Delegated officer report for planning application

Application no.	143835/FO/2025		
Date registered valid:	27 August 2025		
Proposal:	Installation of collection window and retention of entrance doors.		
Address:	1 Piccadilly Gardens, Manchester, M1 1RG		
Ward(s):	Piccadilly		Ward
Applicant:	PLK Chicken UK Ltd		
Agent (if any):	Mr Tom Roberts Firstplan		
Case officer:	Sam		Elliott
	Tel: 0161	219	2856
	Email: sam.elliott@manchester.gov.uk		
Recommendation:	Refuse		
Date of recommendation:	15/10/2025

Figure 4: Original elevation prior to installation of service hatch.

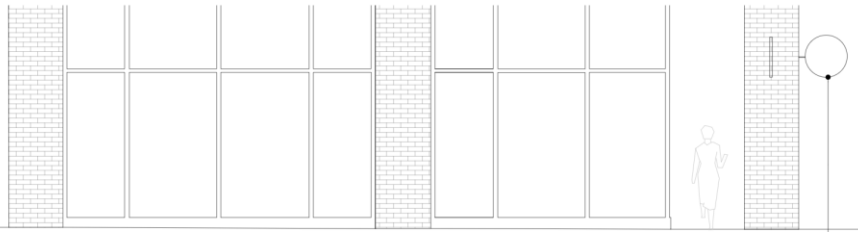
The proposal includes a revised design of the service hatch installed within the northeastern elevation following the refusal of application 137200/FO/2023.

Figure 5: Service hatch and doors installed prior to, and refused in, application 137200/FO/2023.

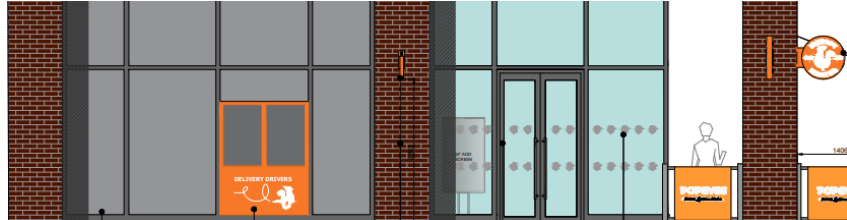
The existing hatch window would be removed, being replaced by three horizontal and two vertical mullions, each with a 50mm thickness. This would facilitate 4no. glazing panels with a recessed sideways-sliding window hatch in the upper portion. Within the elevation, the proposed hatch window would have a height of 1519mm and a width of 1438mm.

In consideration of the above, the Council considers that that the revised hatch design would continue to materially alter the visual cohesion of the frontage and form an awkward addition to the architectural expression of the prominent facade elevation. The formerly uniform glass pane would still be visually disrupted through the segmentation into 4no. separate panels and feature a partially recessed hatch window. Where the hatch's frames would be incorporated into the elevation against an otherwise consistent pattern of glazing, they would add a degree of bulk to the upper portion of the panel, appearing top-heavy despite being slimmer than the existing frame. While it is understood that the applicant intends to remove the exterior orange vinyl and the revised design does not feature the solid signage areas in orange and grey above and below the hatch window, the works would instead introduce obscure glazing to the panels below the hatch, resulting in a patchwork appearance to the glazing diminishing transparency and reducing display area.

The Council considers that the revised service hatch would continue to fail to appear well-integrated into the glazing, therefore undermine the architectural cohesion the principal architectural feature of the ground floor units. The hatch would disrupt the visual flow across the glazing and set it apart from the rest of the façade. As such, the design of the revised service hatch would continue to appear incongruous in the building's overarching design.

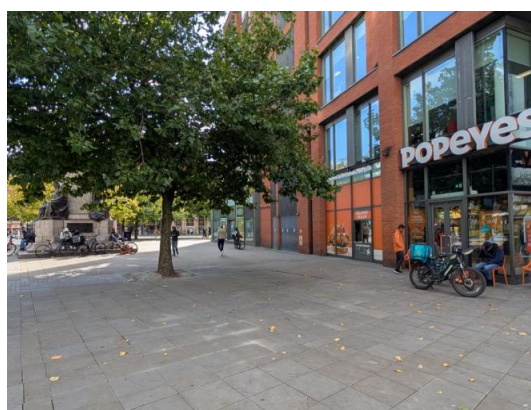
Highways Safety
